# Planning Permit Officer Report

PA2402894: 1013-1055 Collins Street, DOCKLANDS

Planning Permit Officer Report  
Development Approvals & Design

Figure 16: Laneway along Eco Park Interface

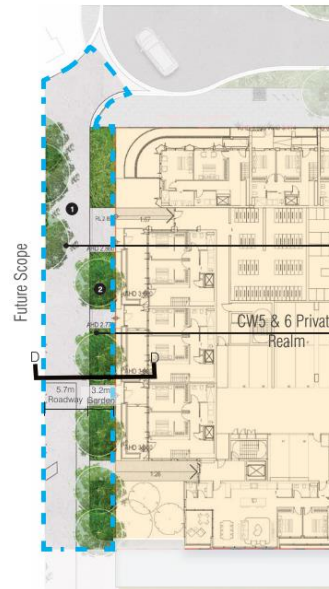
- A 5.7m wide road with a 3.2m wide nature strip/garden is proposed to the west of CW6 (between CW6 and Eco Park) (Figure 16). This road/laneway will provide pedestrian access to residents and vehicular access to emergency and CoM service vehicles. Small-medium trees will delineate the private realm from the future formal and public Eco Park.
- This is consistent with the DP (see Figure 17 below).

Figure 18: Development Plan vs proposal

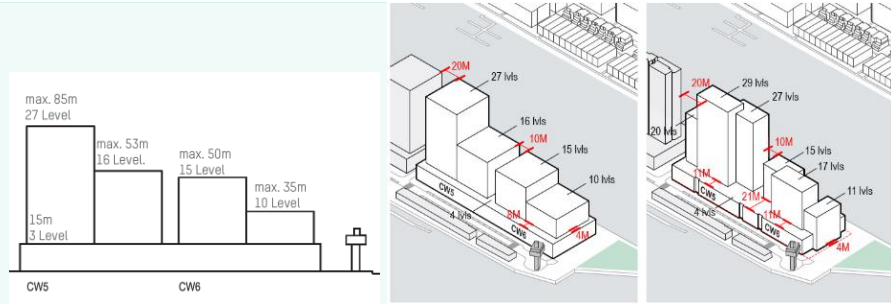
- The DP envisages a built form of 3 levels of shared podium between CW5 and CW6 and split towers with heights of:
  - CW5: 16 levels (53m) and 27 Levels (85m), with approximately 50/50 split.
  - CW6: 10 levels (35m) and 15 Levels (50m), with approximately 50/50 split.

- The proposal is for a 4 level, shared podium and spilt towers with heights of 20 (70.27m), 27 (92.48m) and 29 (99.34m) levels for CW5 and 11 (41.60m), 15 (54.48) and 17 (61.81m) levels for CW6. The massing is approximately 65/35 when viewed from the north and south. While a variation is proposed, the development continues to be generally in accordance with the DP. This is achieved through various sight lines when viewed from the east and west, due to the generous setbacks provided (see tower setbacks below).

Figure 22: 50/50 mass split (top image) and 65/35 mass split (second image) when viewed amongst approved developments from the north

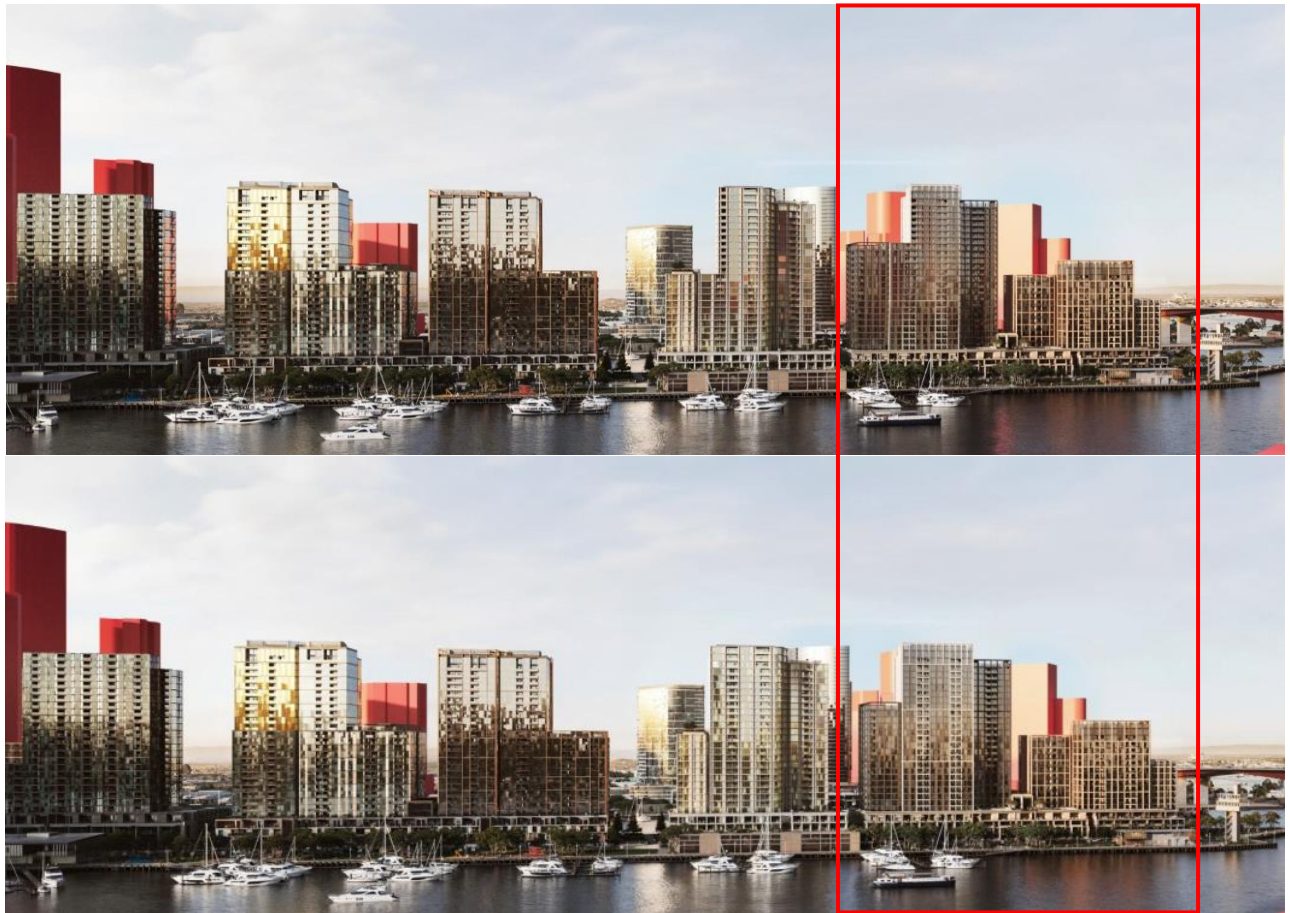
83. The massing shift from 50/50 to 65/35, is visible when the proposal is viewed from the north or south, in isolation (see Figure 21). However, when viewed in the in the context of the recently approved developments in Yarra's Edge and Fishermans Bend, this change has little impact on the skyline (see Figure 22). This is also the case when viewed from oblique angles.

Figure 24: Overshadowing of the Yarra River is within limits of the controls

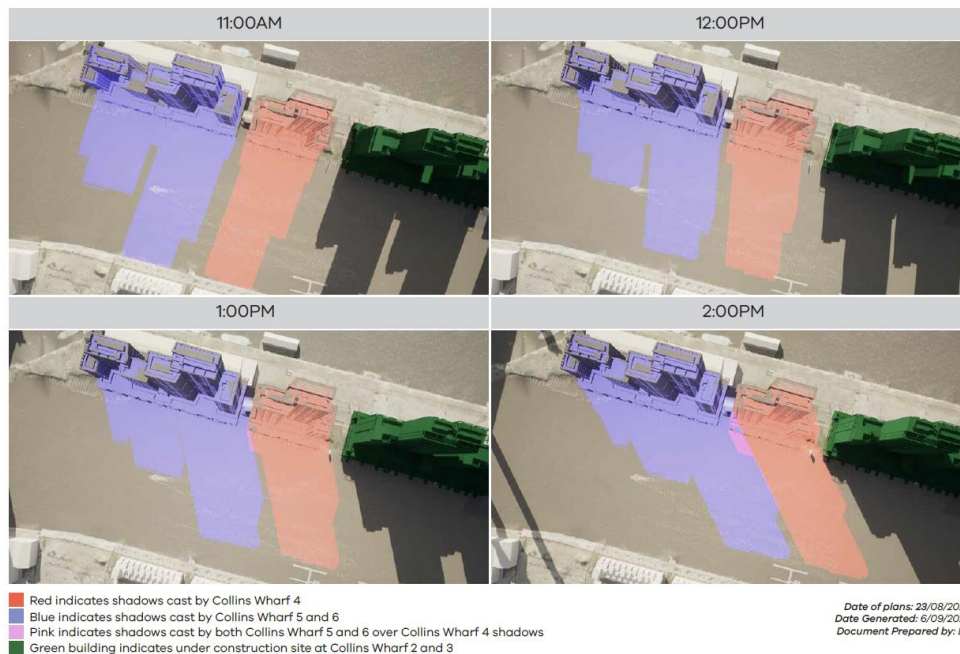
99. The proposal is located on the south side of Collins Street and will therefore have minimal overshadowing on the Collins Street public realm.
100. Pursuant to clause 4.0 of Schedule 2 to the Docklands Zone, it is prohibited to construct a building which would cast a shadow across the south bank of the Yarra River between 11.00 am and 2.00 pm on 22 June, excluding mooring poles, marinas and gangways. The diagrams below demonstrate that the development will not overshadow the Yarra River beyond what is permissible.
